Freightliner
Service Bulletin

General Information

Fig. 1, Circuit Board Wiring

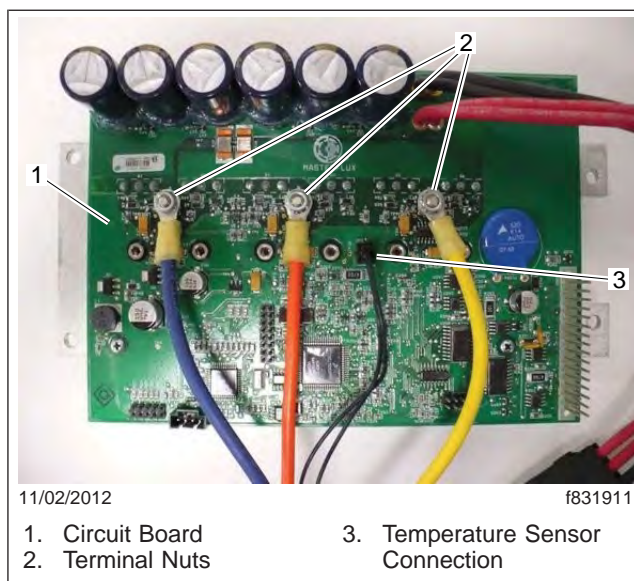
A design change has been made to the ParkSmart internal controller circuit board to protect against high voltage damage. The new controller is installed in all vehicles manufactured from June 21, 2012.

- 2.1 Connect the three phase-wires to the new circuit board terminals as shown in [Fig. 1](#). Install the blue wire on the left terminal, the orange wire on the middle terminal, and the yellow wire on the right terminal. Tighten the nuts 10 lbf-in (113 N-cm).
